**Landscape Review Committee**  
**Hybrid In-Person & ZOOM Online Meeting**  
**Wednesday, February 19, 2025 - 12:00 PM**

## **EXHIBIT 1 - STAFF REPORT**

**DATE:** February 19, 2025  
**TO:** Landscape Review Committee Members  
**FROM:**  
**SUBJECT:** Landscape Plan Review Application (L 46-24)

- DOCKET:** L 46-24 (Landscape Plan Review)
- REQUEST:** Approval of a Landscape Plan Review for property at 2631 NE McDonald Lane
- LOCATION:** 2631 NE McDonald Lane, Tax Lot R4416BA 02900

Figure 2. Landscape Plan

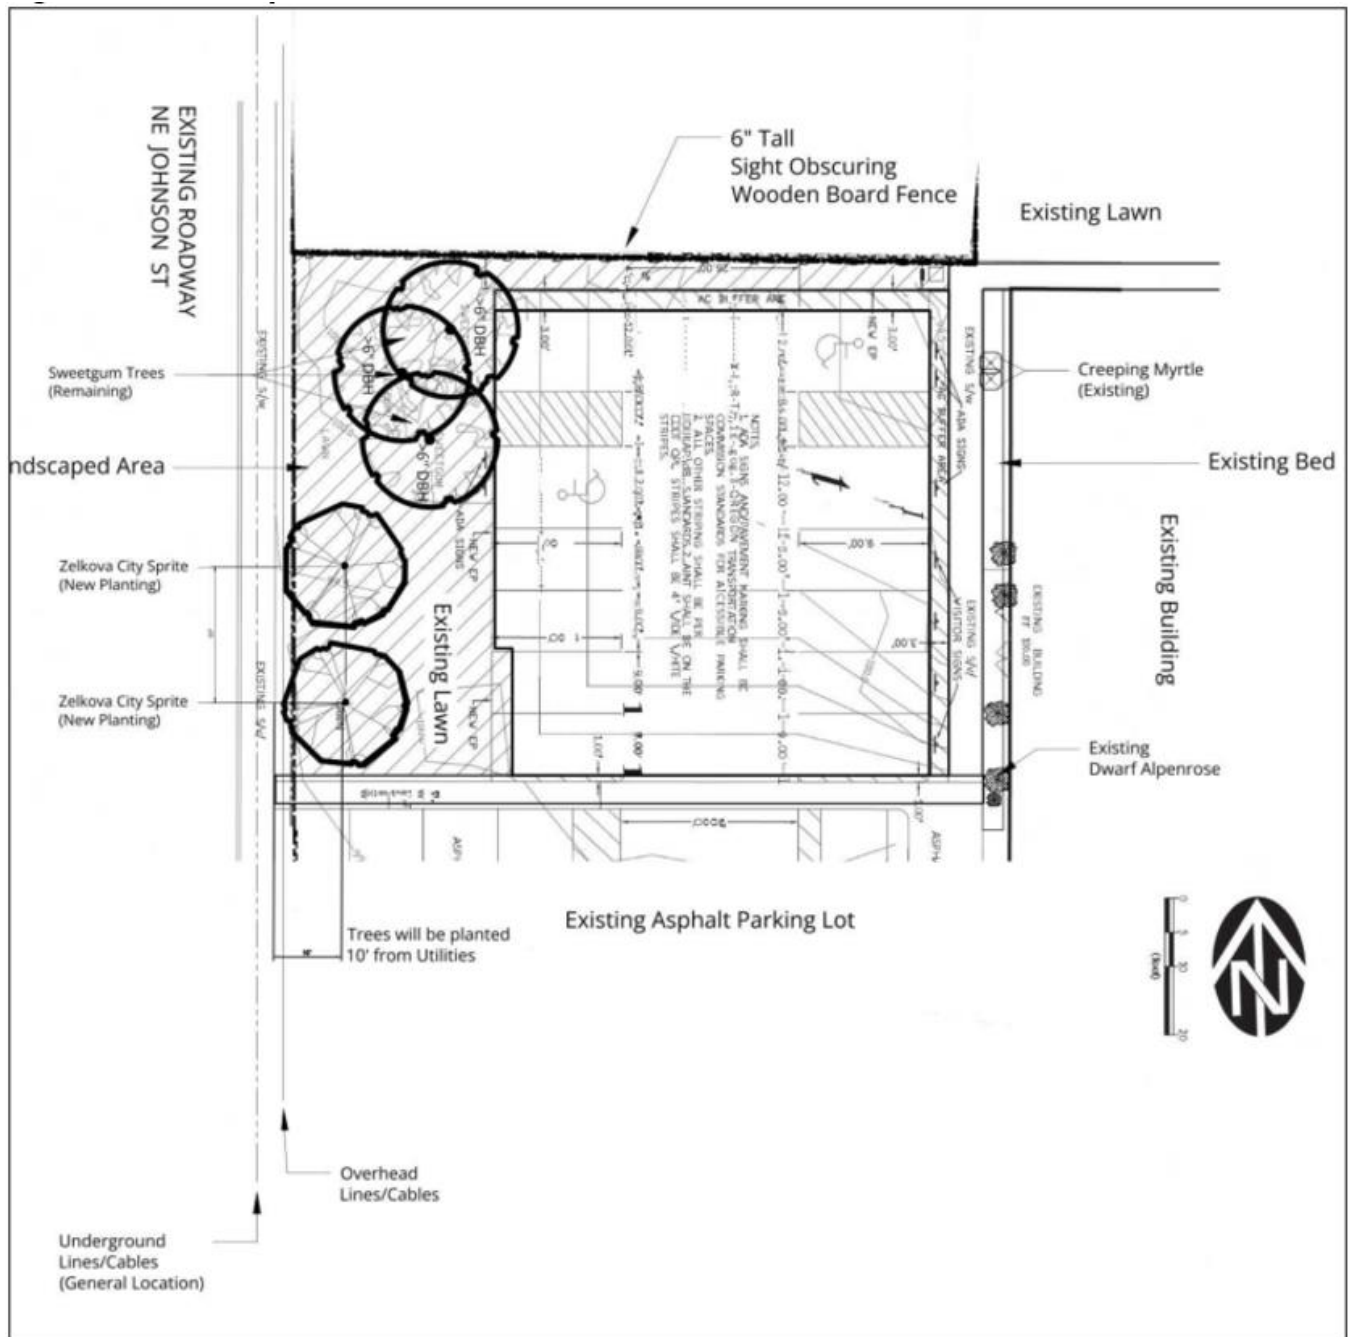
The landscape plan shows underground utilities and overhead wires along NE Johnson Street. Both utilities cause potential conflict with street trees that must be planted as part of this project. The applicant must provide adequate spacing from the utilities or select the appropriate street under overhead wires.

5. Prior to the issuance of a building permit, the applicant shall submit a revised landscape plan that indicates the size of street trees at the time of planting, measured at six (6) inches above ground level. (MMC 17.57.060(A))

9. Prior to the issuance of a building permit, the applicant shall submit a revised landscape plan that identifies street trees to have a minimum diameter of two (2) inches measured at six (6) inches above ground level and notes street trees are to be healthy grown nursery stock with a single straight trunk, a well-developed leader with tops and roots

11. Prior to the issuance of a building permit, the applicant shall submit a revised landscape plan that identifies those existing trees to be street trees, or the applicant shall provide the planting of new trees in compliance with Chapter 17.58. (MMC 17.58.090(F))

**Figure 3. Landscape Plan**

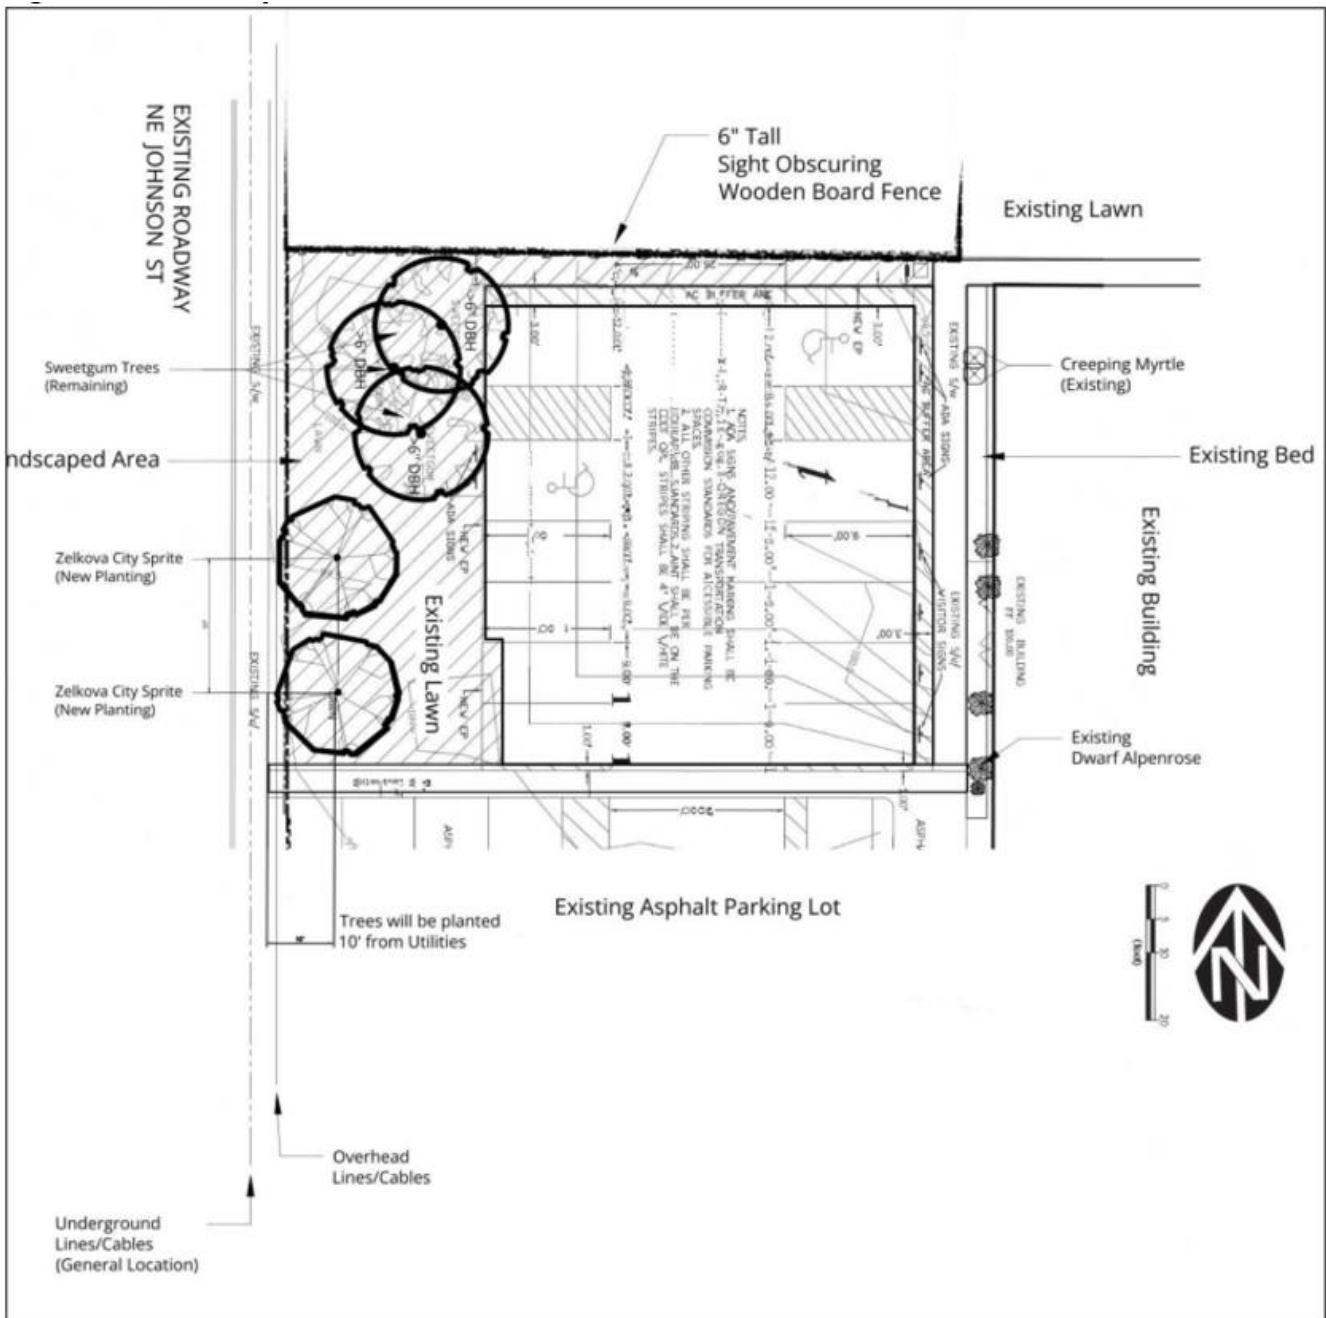
The applicant has proposed expanding the religious institution's parking lot. The city is reviewing the parking lot and associated stormwater improvements as a separate permit. The landscape plan indicates a new parking lot and landscaped area with the retention of trees and lawns and the planting of two (2) new trees along the right-of-way. ***See Figure 4 (Landscape Plan).***

1. Prior to the issuance of a building permit, the applicant shall submit a revised landscape plan in compliance with the conditions of approval and receive approval of the landscape plan. (MMC 17.57.050(A)(1))

6. Prior to the issuance of a building permit, the applicant shall submit a revised landscaping plan with sight-obscuring screening along the northern property line adjacent to the project area. (MMC 17.57.070(B)(2))
